March 1, 2017
DIALYSIS CENTER OF LINCOLN
NORTHWEST UNIT
LINCOLN, NEBRASKA

ADDENDA #2 – For Bid Documents Dated 2-15-2017

Item No. 2-2: Sheet A1.0

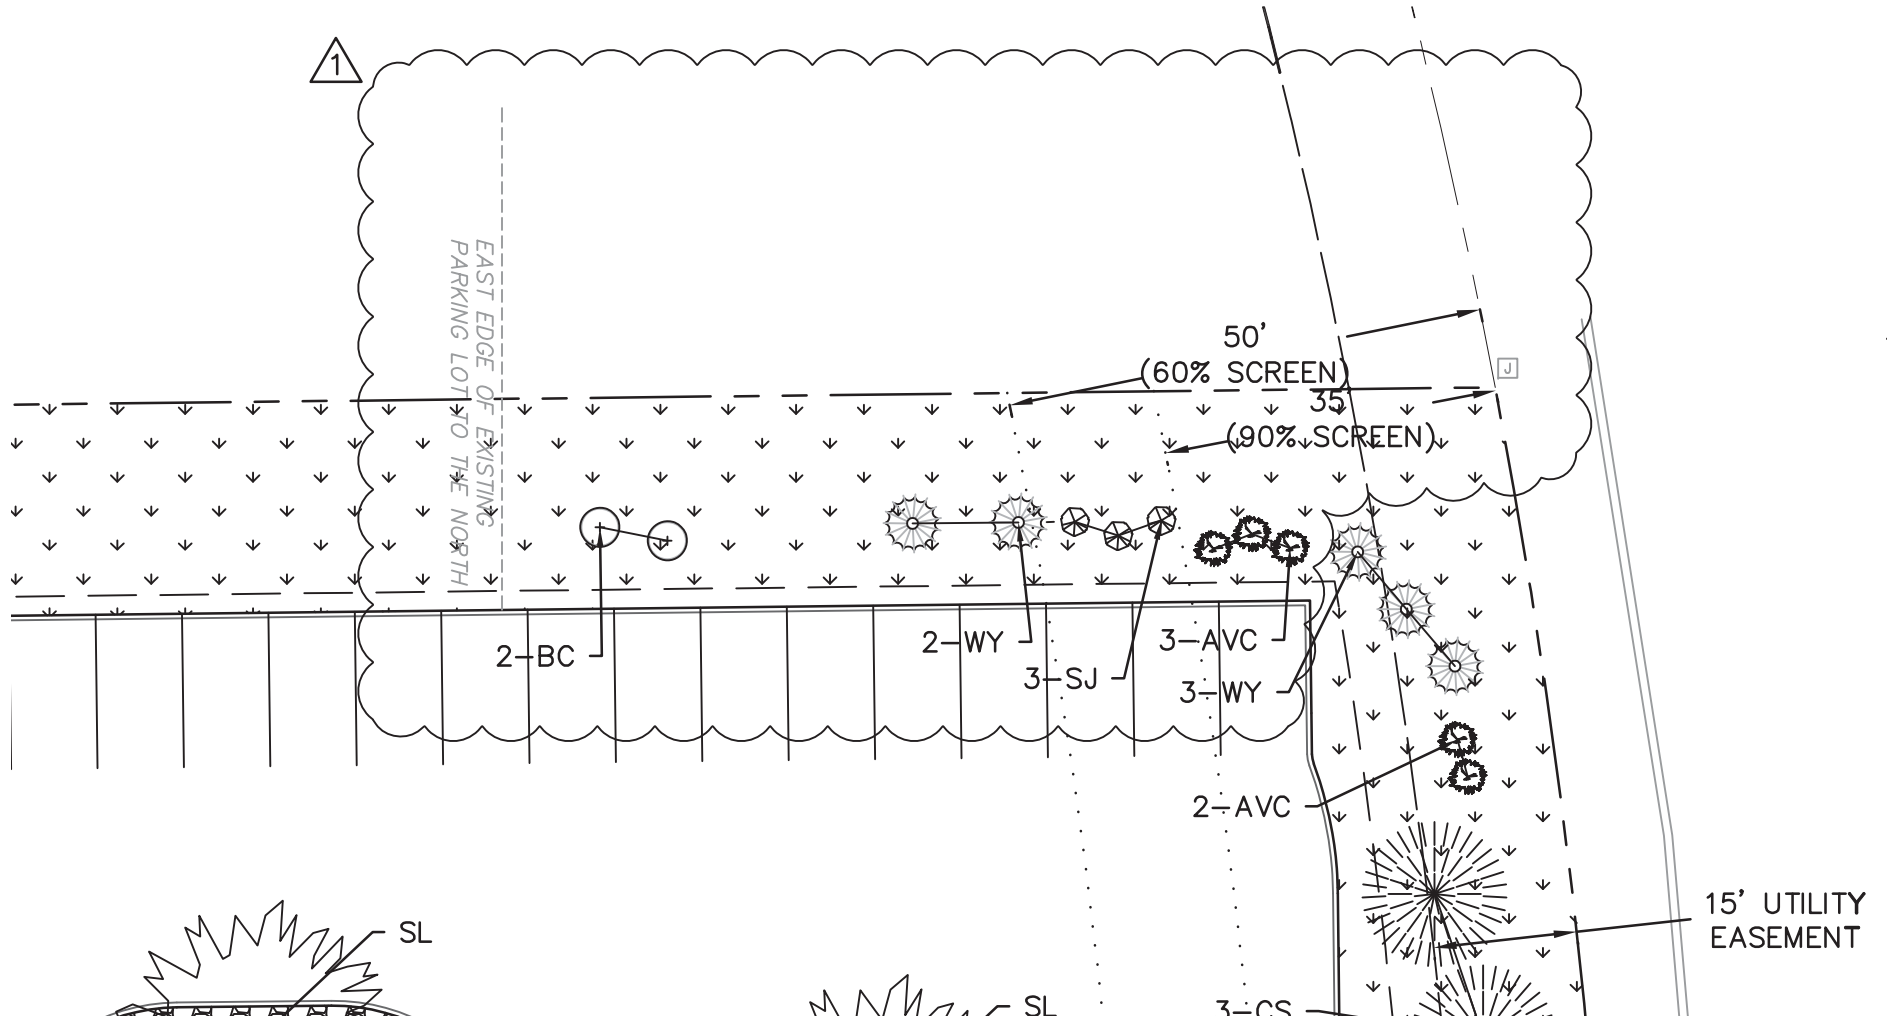
- A. At the Code Plan Main Level, in addition to the FEC (Fire Extinguisher Cabinet) shown in Corridor 119 and 145, add a note that there is a FEC in Hall 102A and in Staging Area 128. Also, note there is a FE (Wall Mounted Fire Extinguisher) at Mech Lofts 200 and 201.

Partial Plan From Landscape Plan Sheet L1.01
Addenda No. 2 - Page: AD2-1
Olsson Assoc. 3-1-2017

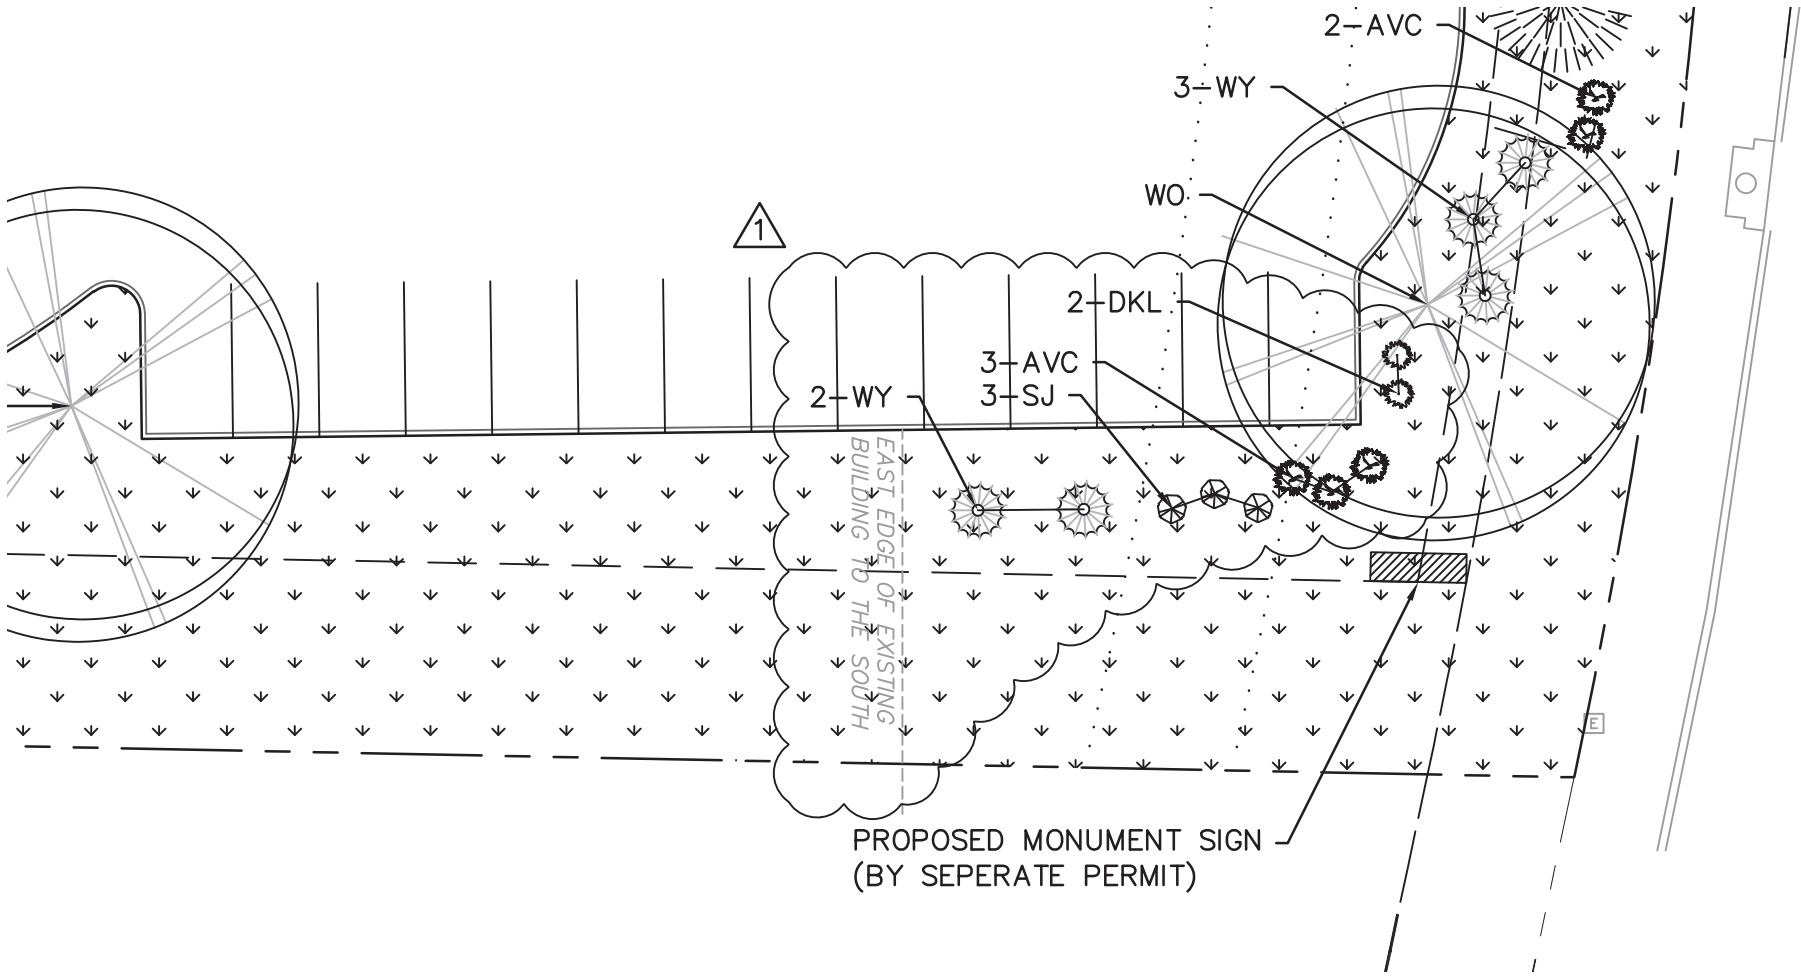
- A. At the Site Landscape Plan, add shrubs at the Northeast and Southeast corner of the project and adjust the landscape schedule as shown on the attached sheets AD2-1, AD2-2 and AD2-3.
